**CITY HISTORIC PRESERVATION BOARD AGENDA**  
**May 1, 2023**

**FILE NO:**  
**HIST-23-0003 - QUASI-JUDICIAL**

**PROJECT: 1428 WOOD RESIDENCE FRONT PORCH ADDITION**

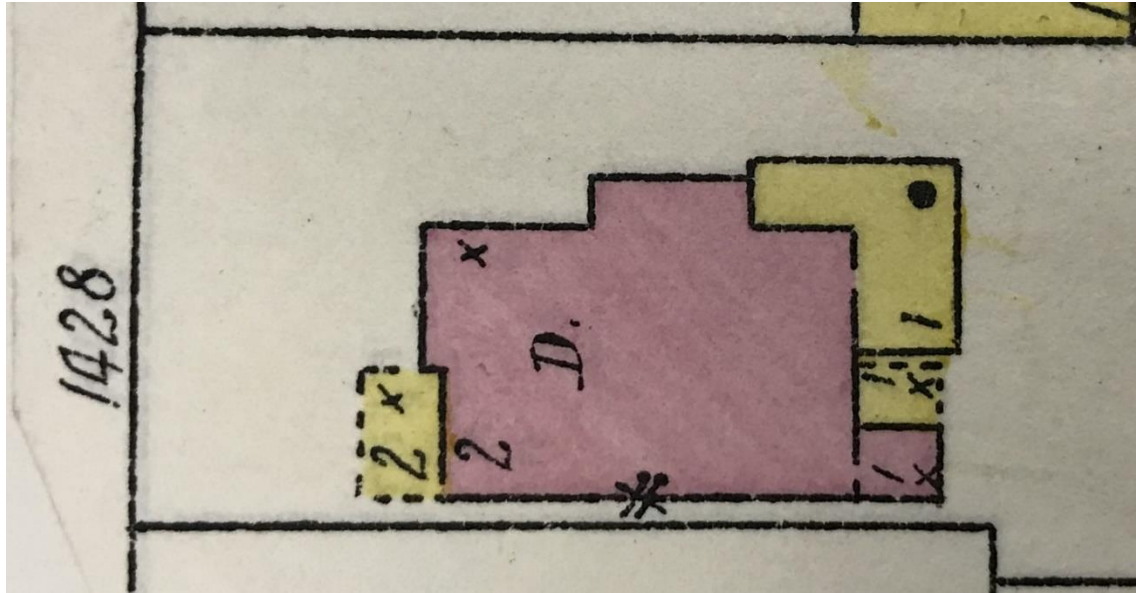
The submitted Report of Acceptability for the 1428 Wood Front Porch Addition project proposed a new 10' x 10' x 12' gable roof front porch addition. The existing house has an existing portico with a gable roof with the same slope as the main the

house. Staff raised concerns with the proposed porch addition in terms of its scale and the proposed roof type and slope. This concern was shared with the Applicant. An important fact to consider with the proposed addition is that there is no obvious evidence of a front porch on the historic home, but there is information that would make one think otherwise. The 1950 Sanborn Map does indicate a shingle roof covering at the front of the house that could be a two (2) story framed structure like a porch or enclosed living space (see “1950 Sanborn Map” attachment).

The Applicant revised original plans with a design that is more appropriate and compatible with the existing architectural character of the residence (**see “Revised Front Porch Addition Plan” and “Project Statement Supplement”**). The new design is a 10’ x 10’ front porch, 6” x 6” columns with decorative molding at the top and bottoms of the columns, trim on the face of the columns and railing. Material colors are white to match homes exterior and asphalt shingle matching the existing roof material. The decorative additions are compatible and minimal.

- 1) A plan set drawn to scale, including front architectural elevation and plan view is submitted. The plans will specify all design details as specified on the original plans as applicable, the revised plans and revised project statement.
- 2) The height of the proposed front porch addition shall match the top of the arch of the first-floor window.
- 3) The slope of the front porch roof shall be between 2:12 and 4:12 (the minimum for allowing shingles).
